AUTOMATIC TRANSMISSION SERVICE GROUP

REVISED EDITION

Since the introduction of the THM 440-T4 Transaxle in April, 1984, there have been many major engineering design changes. These changes have affected nearly every part used in the THM 440-T4. This Update Handbook will explain each change, the parts affected by the change, and any parts interchangeability problems created by the change.

Figure 82

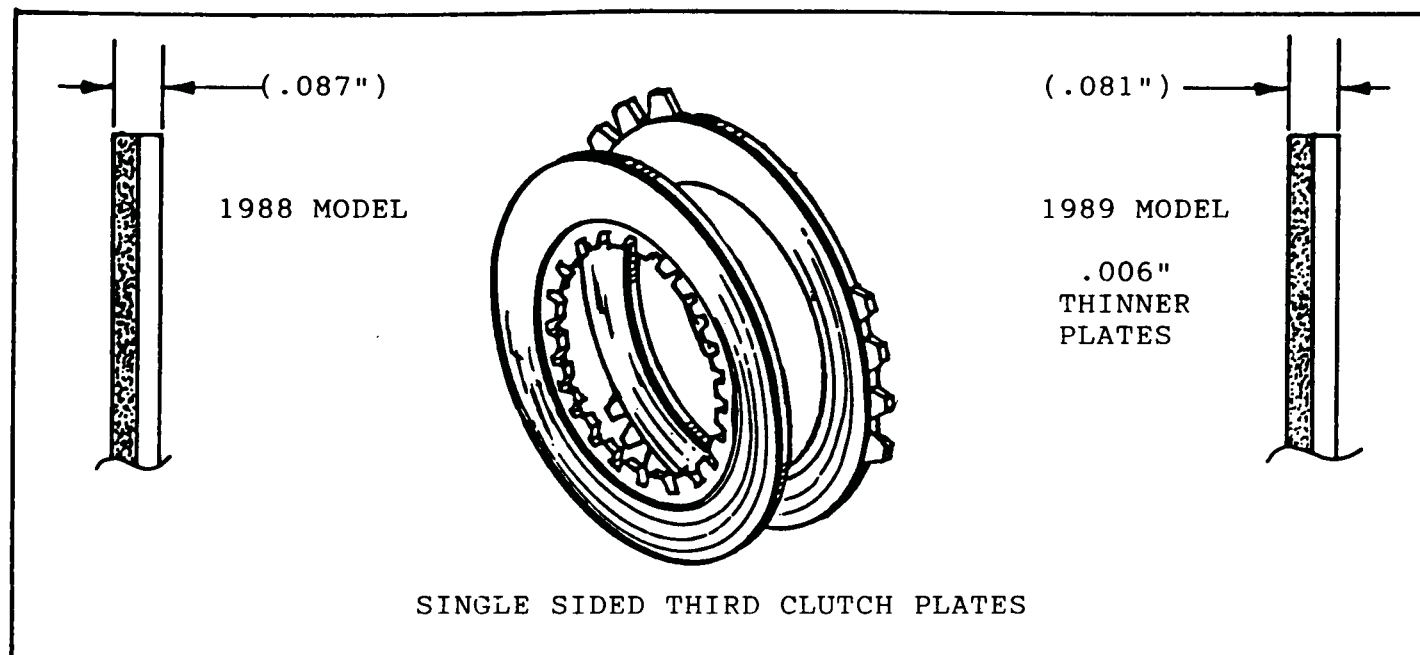
- (1) Single Sided 3rd Clutch Plates - Both inside and outside spline plates are .006" thinner for 89, to make room for the two additional plates (See Figure 82).

Figure 83

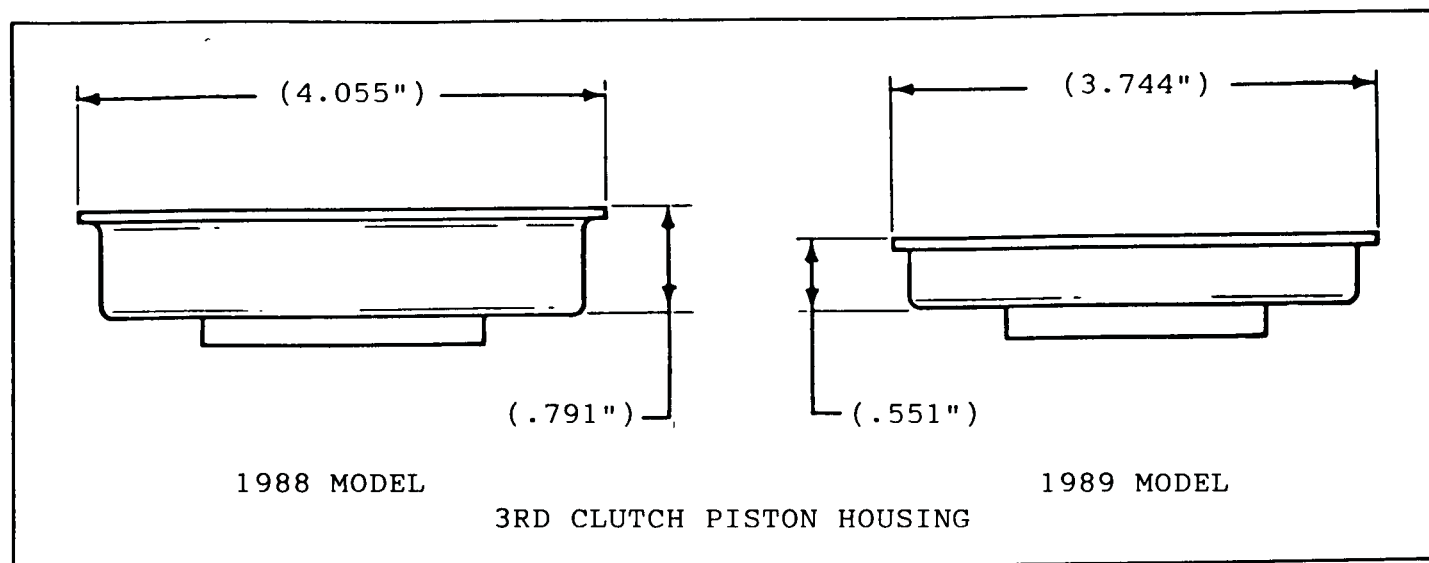
- (2) 3rd Clutch Piston Housing - Was decreased in overall size for calibration considerations (See Figure 83).
- (3) 3rd Clutch Piston - The 3rd clutch piston outer seal is now moulded to the 3rd clutch piston (See Figure 84).

Figure 85

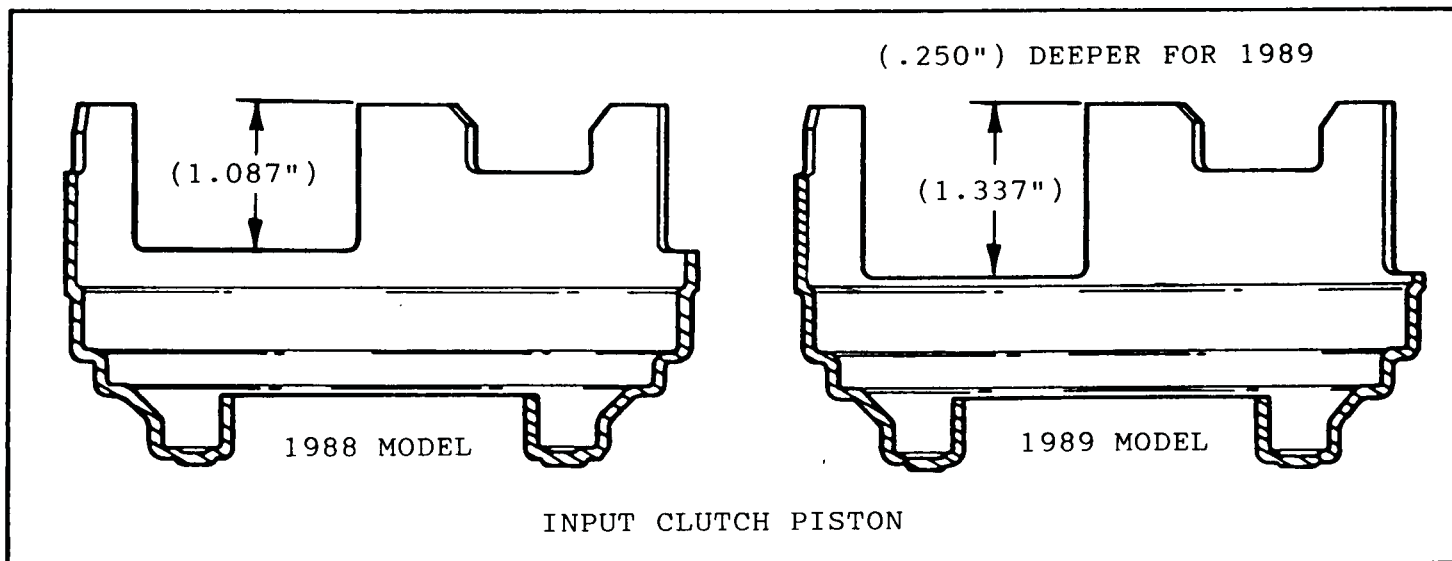
- (4) Input Clutch Piston - The cutouts in the piston for the 3rd clutch plates are .250" deeper to accomodate the additional two clutch plates in the 3rd clutch pack (See Figure 85).

Figure 86

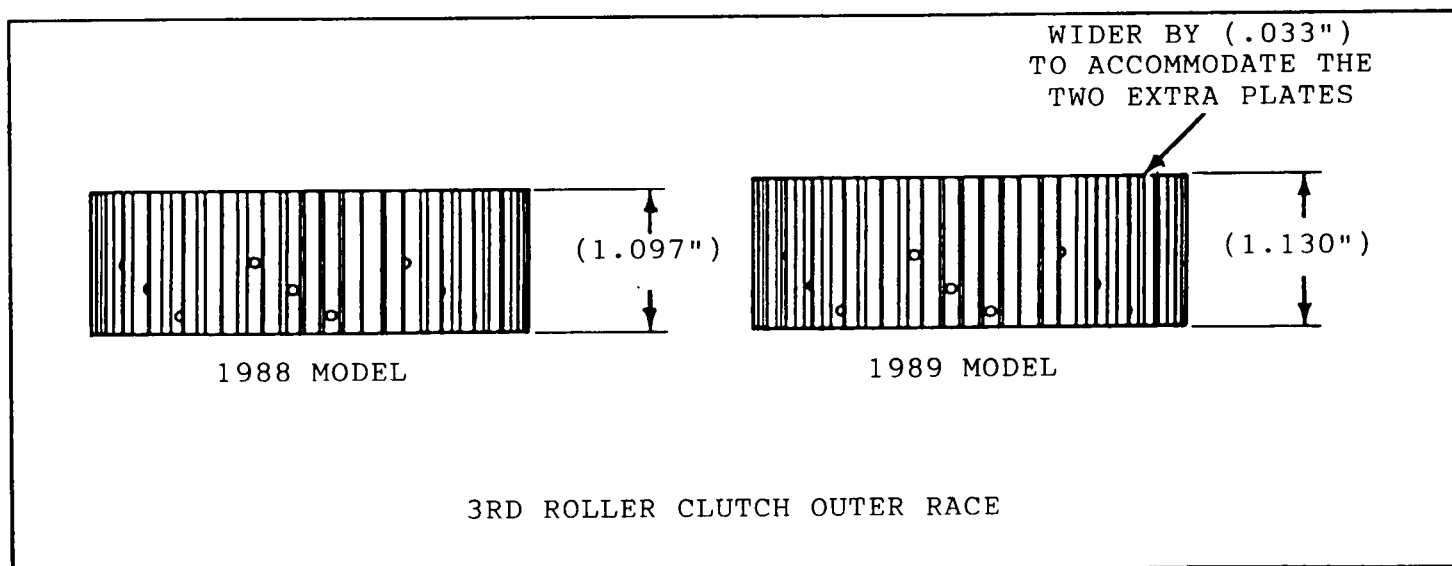
- (5) 3rd Roller Clutch Outer Race - The outer race was made wider by .033" to accomodate the two extra plates. The rollers have not changed in width (See Figure 86).

Figure 87
87

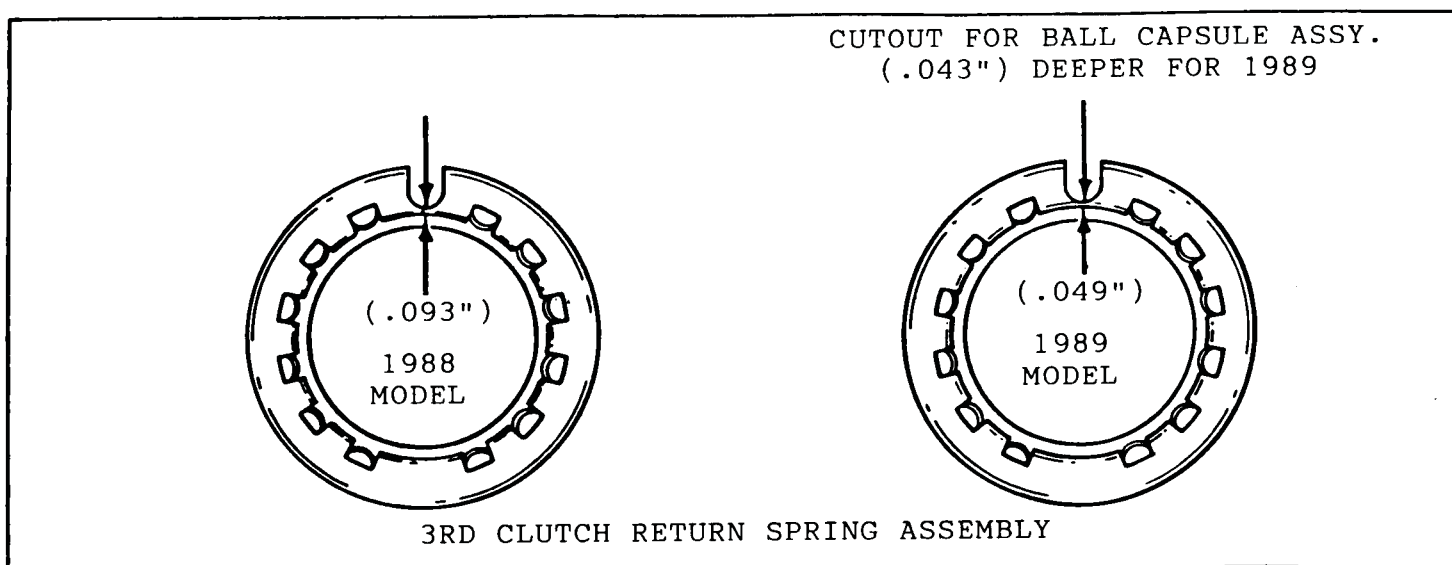
- (6) 3rd Clutch Return Spring Assembly - The cutout in the retainer is .045" deeper to accomodate the relocated ball capsule in the new (Smaller Diameter) 3rd clutch piston and seal Assy. (See Figure 87).

Figure 88

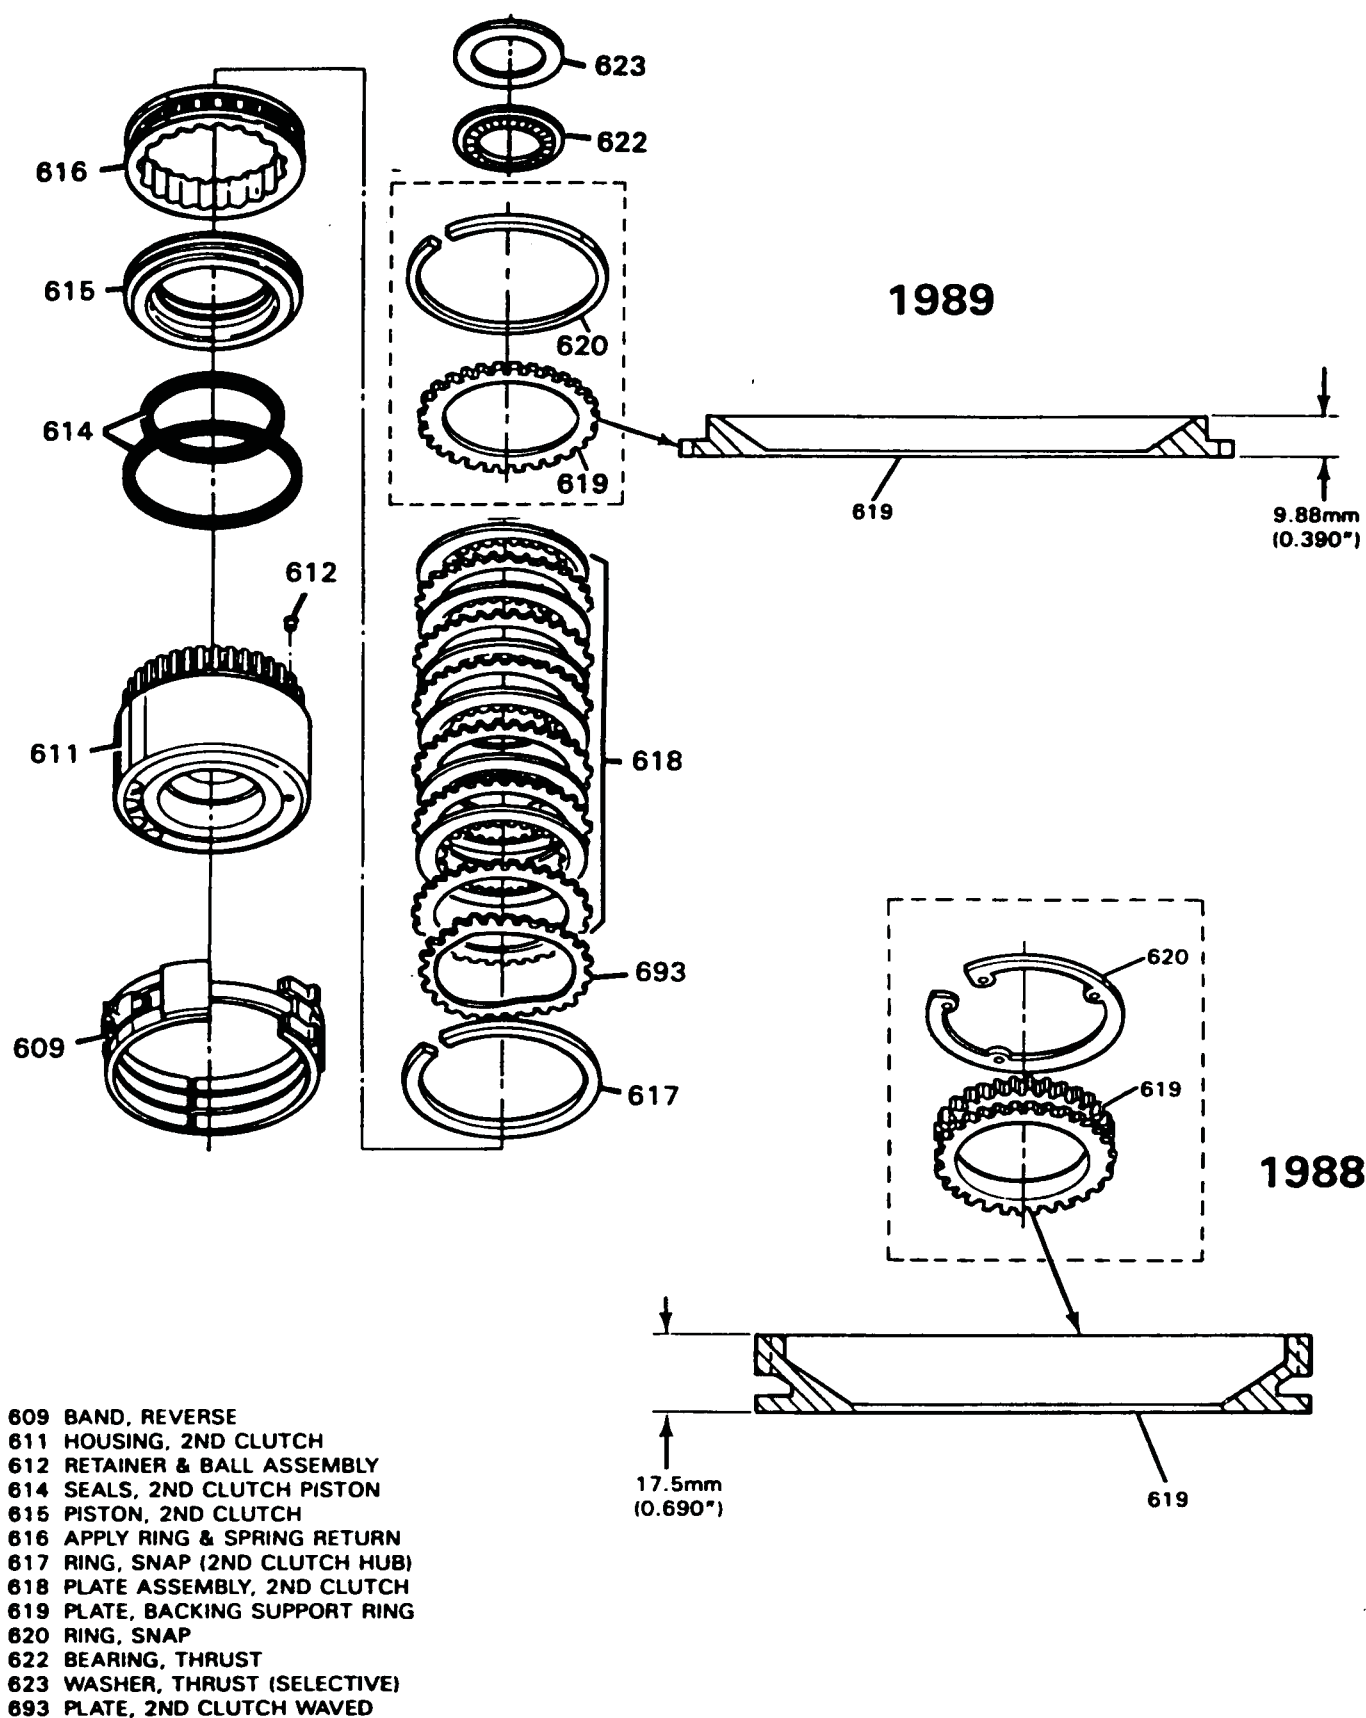
CHANGE: 2nd Clutch Backing Plate was redesigned (See Figure 88).

- (1) 2nd Clutch Backing Plate - "Windows" in backing plate are eliminated which makes the backing plate less prone to warpage. Also notice (See Figure 88) that the support ring has been eliminated from the backing plate and is no longer used, because "Engine Torque Management" was added as an ECM function. This was one of the reasons for the addition of the 2nd clutch switch in 1988.
- (2) 2nd Clutch Backing Plate Snap Ring - The new snap ring is only half as wide as the previous models and must be used with the third design backing plate.

2nd Clutch Backing Plate (3rd Design).....8668566
2nd Clutch Snap Ring (3rd Design).....8668567

Figure 89

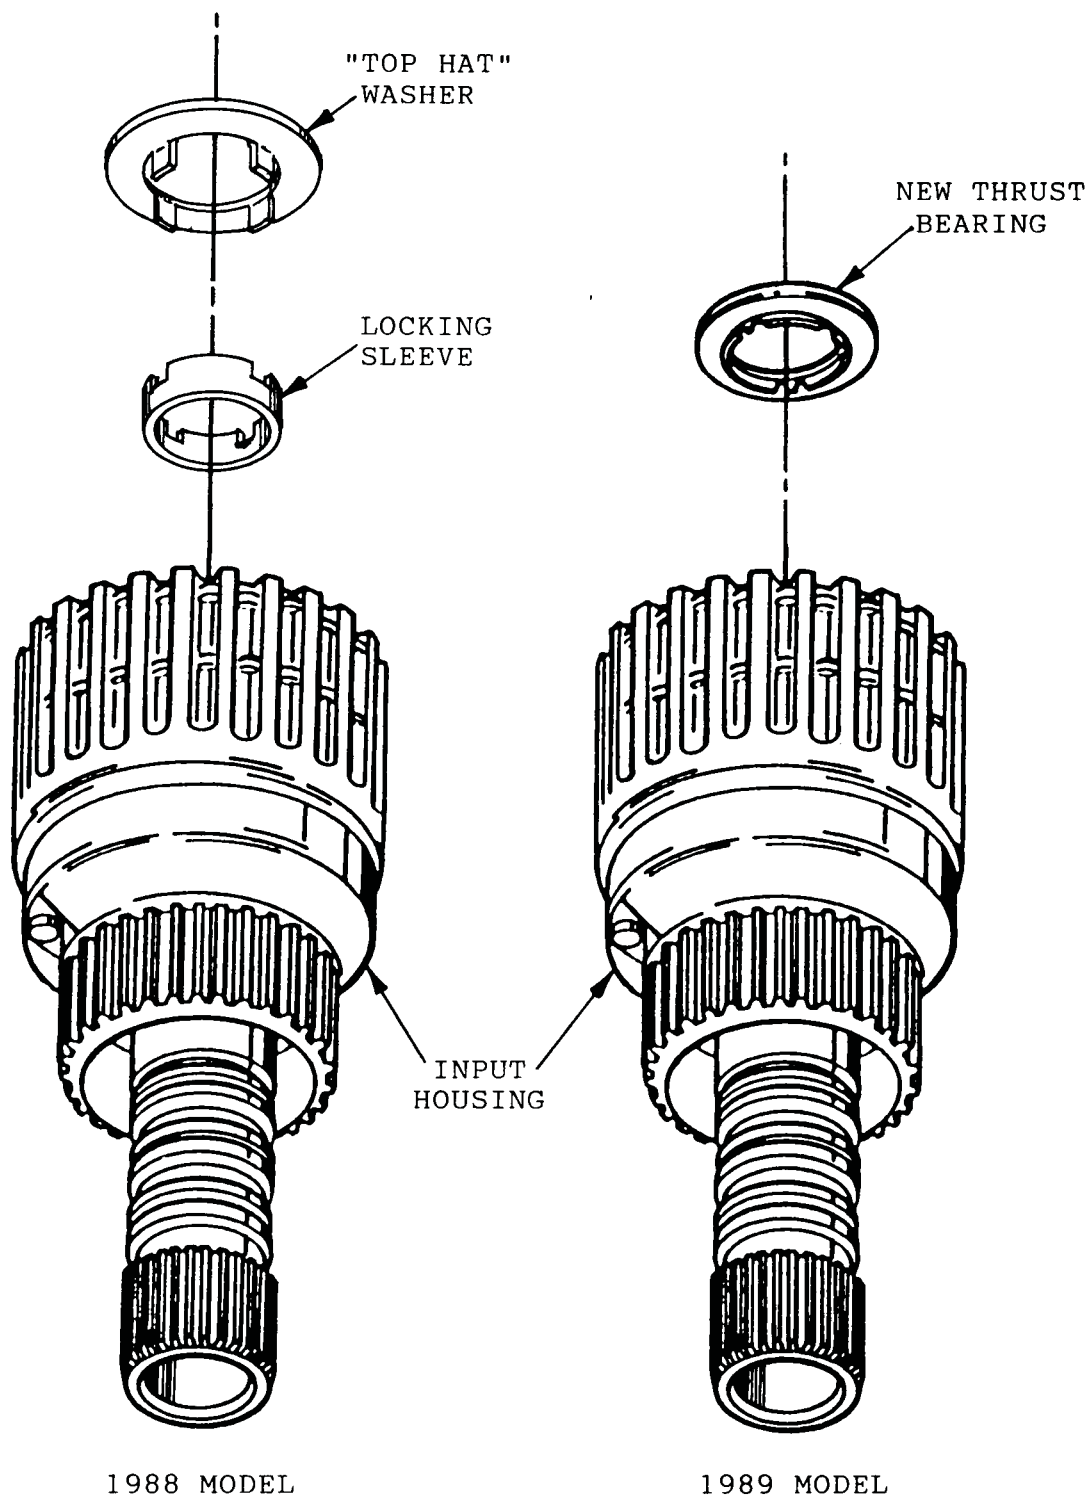
CHANGE: A new Thrust Bearing Assembly replaces the "Top Hat" Thrust Washer and Lock Up Sleeve in the input housing. (See Figure 89). The new bearing and related parts went into production on all 1989 models on November 28, 1988 (Julian Date 333).

Thrust Bearing Assembly (New Design).....8668422
3rd Roller Clutch Complete (New Design).....8657046
Service Package.....8662970
Contains the following;
1. New design Input Housing.
2. New design Thrust Bearing Assembly.
3. New design 3rd Roller Clutch Complete.
4. Instruction Sheet.

Figure 90

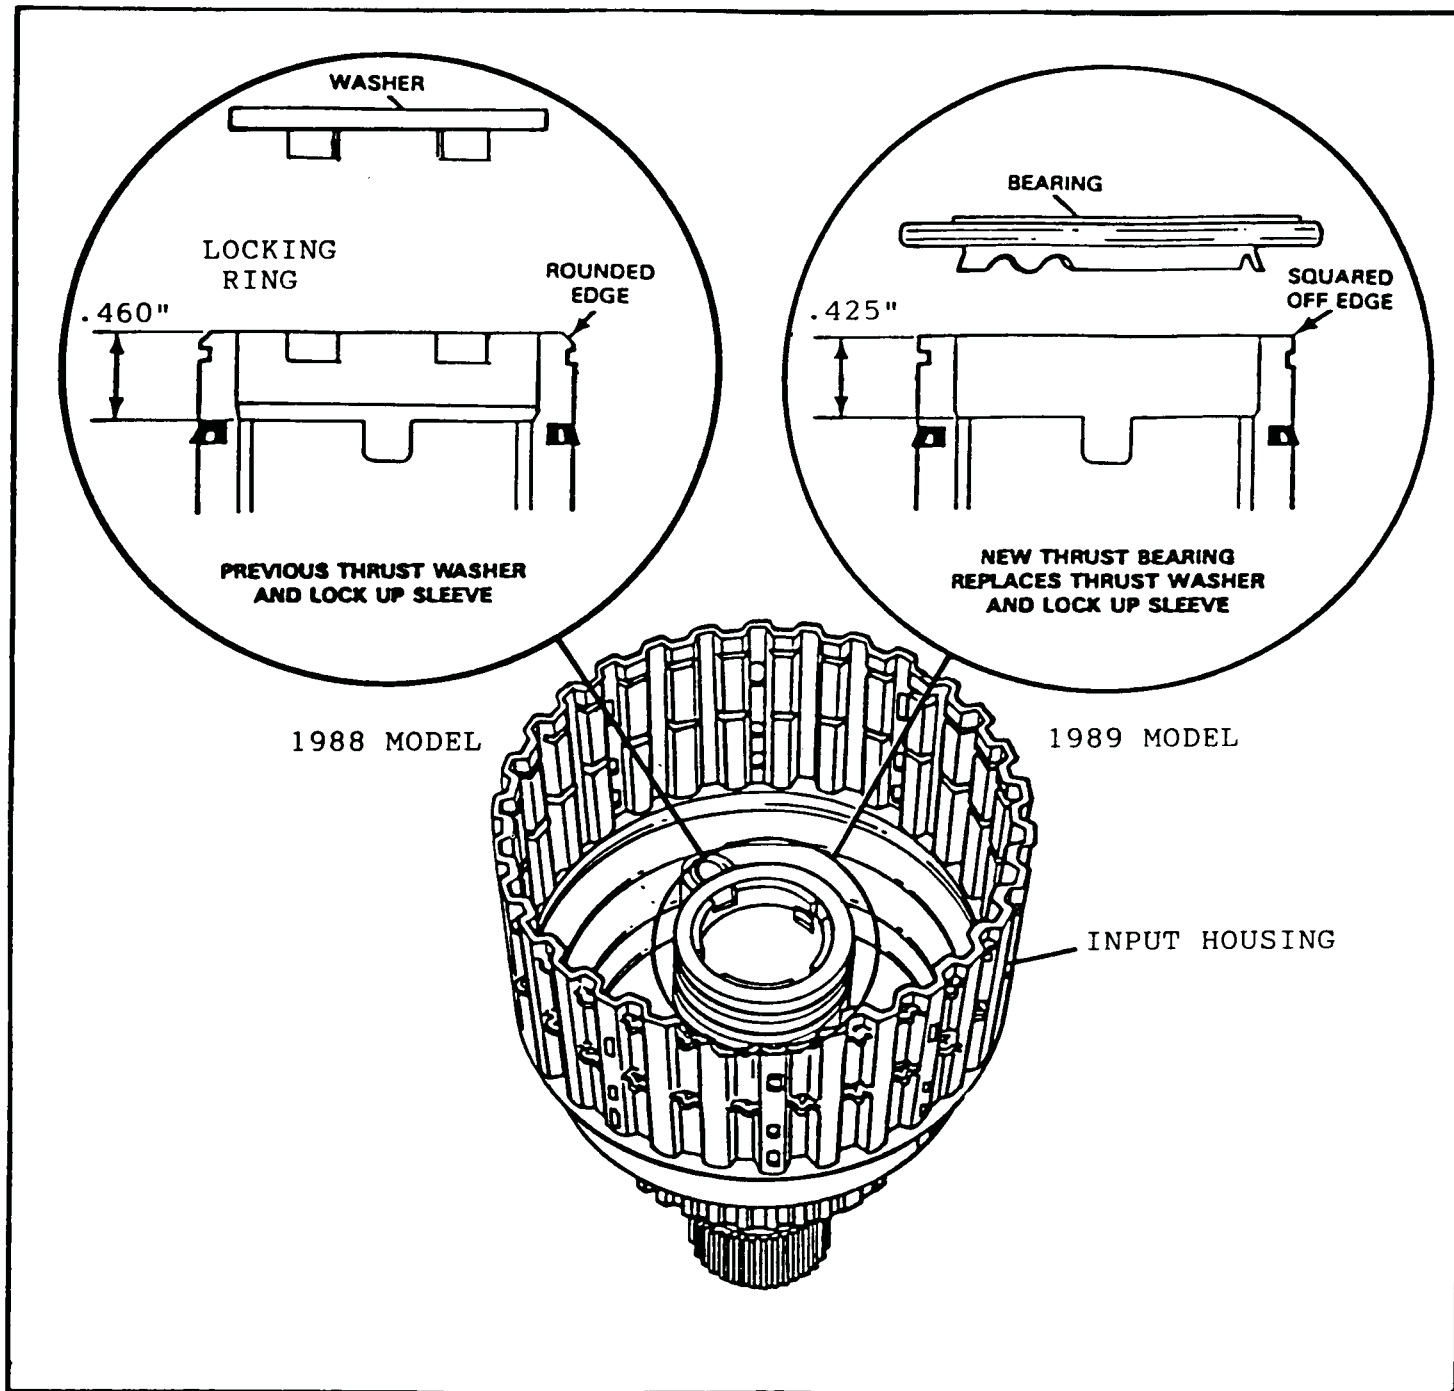
- (1) Input Housing - Surface on the input housing where the new bearing assembly rides, has been reduced by .035" to accommodate the increased thickness of the new bearing (See Figure 90).
- (2) "Top Hat" Thrust Washer - Eliminated (See Figure 90).
- (3) Lock Up Sleeve - The lock up sleeve is no longer needed and has been eliminated (See Figure 90).
- (4) 3rd Roller Clutch Lube Dam - The inside diameter has been increased by .256" to accommodate the larger diameter new bearing, and the lip on the lube dam eliminated for increased lube flow to the 3rd roller assembly (See Figure 91).
- (5) 3rd Roller Clutch Inner Race - Has been machined .040" thinner to accommodate the increased thickness of the new bearing assembly (See Figure 91).
